Standard Stitches Ltd. (Unit-2) (Extension)

05 June 2022

Observations

DEA report

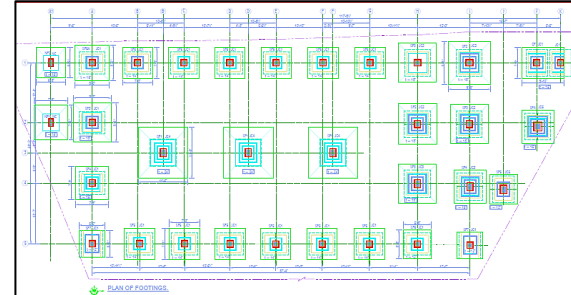
The provided DEA report found incomplete. Almost all columns, footings and beams were retrofitted which has not mentioned in the DEA report. IMRF ($R=8$) framing system is considered without proper justifications. Retrofitting material strength/test report was not available. All BNBC-2006 load combinations were not mentioned in the report. The building engineer is required to complete the DEA report and submit to RSC for review.
